# Technical Service Bulletin

## 01 MIL on and/or oil pressure warning on (DTC P164D00)

01 15 30 2041093/2 July 10, 2015. Supersedes Technical Service Bulletin Group 01 number 15-27 dated June 30, 2015 for reasons listed below.

**Figure 1.** Correct and incorrect position of the oil drain plug.

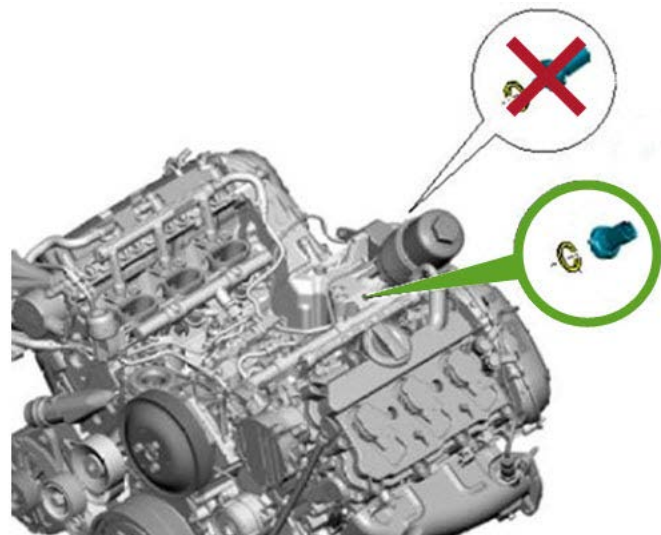
Rubber oil drain plug within the oil filter housing is out of position.

- **If oil pressure is below 1.3 bar:**  
Open the oil filter housing to check the rubber oil drain plug. If the plug is not positioned correctly in the spring (Figure 1), replace the plug.
- **If oil pressure is above 1.3 bar:**  
Replace the low pressure oil pressure sensor F378 (Figure 2).

Improved rubber plug.
